**ATTENTION:** Josh Daley  
**Application Reference:** A006904370  
**Address of Site:** 3 BYRON ST BULIMBA QLD 4171

**RE: Outstanding matters**

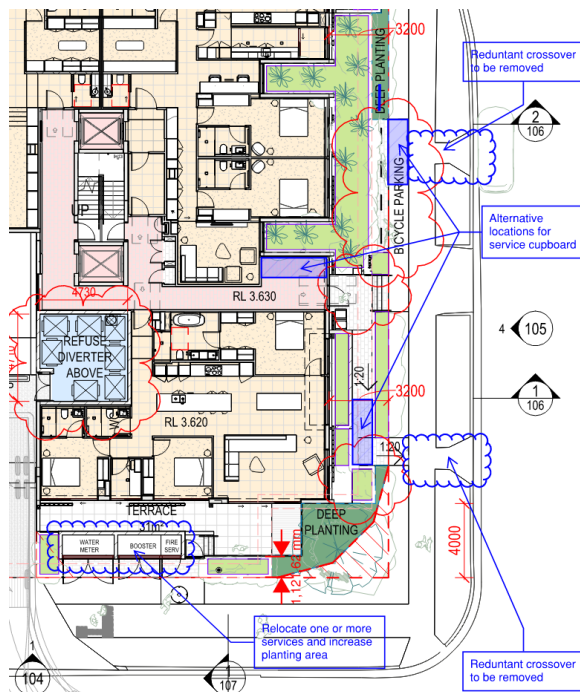
1. The proposal allocates a substantial portion of the Byron Street frontage to services, including a pad-mounted transformer and relocated infrastructure. This outcome significantly undermines the achievement of a cohesive streetscape and built form character by limiting opportunities for casual surveillance and street activation, thereby failing to contribute to an appropriate balance between landscaping and built form. The proposal does not comply with PO3, PO4, PO5, PO6, PO8 and PO28 of the *Multiple Dwelling Code*. Submit amended design to relocate the water meters, booster, and fire services cupboard parallel as recommended below:

- a. Relocate either Water meter or Booster/ Fire service cupboard to the Apollo Road frontage as shown in markups below;
  - b. Provide additional landscaping along the frontage and within the corner truncation area. Alternatively, consider realigning the cupboard to the street to improve residential amenity; and

- c. Reduce the height of the cupboard associated with the water meters to the minimum height required and incorporate a planter of max 500mm depth atop the element to provide variation in height and appearance and soften the built form.

Note: Ensure that the wall and door finishes for the cupboard is of high quality to improve appearance and reduce bulk.
